Phase 2 & 3 Renovations

North Hardin High School

Per your request to relocate existing electric panels from the food storage area to a new masonry chase in the hallway add <u>\$1,055.00</u>

NHHS RENOVATION PHASE 2 -3	JOB NO. 0701B
Peck Flannery Gream Warren Inc. architects	10-16-08
architects 12 North Main Etabeldous, Kardusty 42701	MOD, 3

NEW CMU ELECTRICAL PANEL CHASE

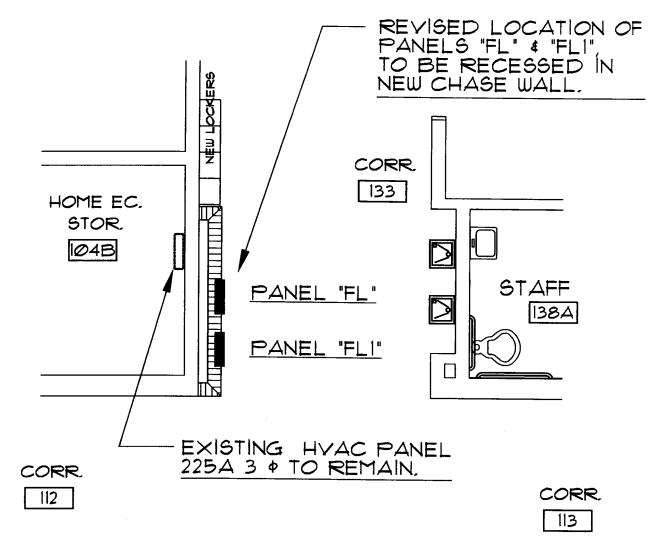
Relocate panels from Foods storage to new chase in hallway.

Provide flush panel covers w/ Corbin lock on door.
